REPORT TO COUNCIL

Application: DP17-0095 **Owner:** 554764 BC Ltd.

Address: 200 Nickel Rd Applicant: James Zeleznik

Subject: Development Permit Application

Figure 3: Detailed view of Interior parking showing access to private patios & parking

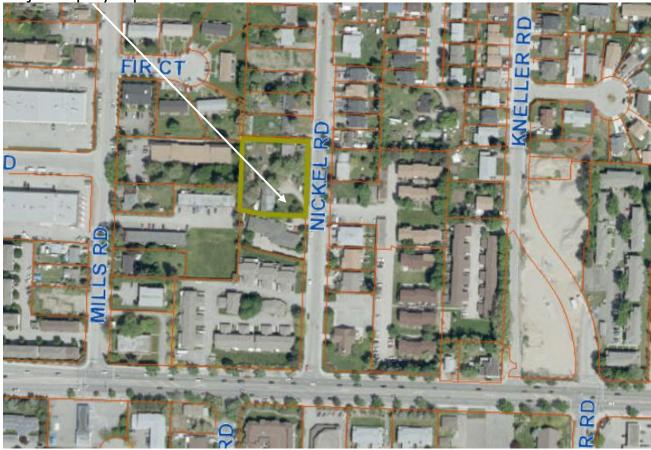
Staff worked with the applicant over several revisions with the goal of trying to improve the form and character of the development. Key design considerations included the building's interface with the streetscape, and the quality of the building's finishes, materials and details. While the revised design does not meet all the OCP's architectural and design guidelines, a number of improvements to the proposal included: greater articulation of the roofline line with the addition of dormers to reduce the horizontal scale of the building and add greater visual interest; and the addition of pergola structures along Nickel Road to help emphasis each units' front entrance. Council Policy No. 367 with respect to public consultation was undertaken by the applicant and all neighbours within a 50m radius of the subject parcel.
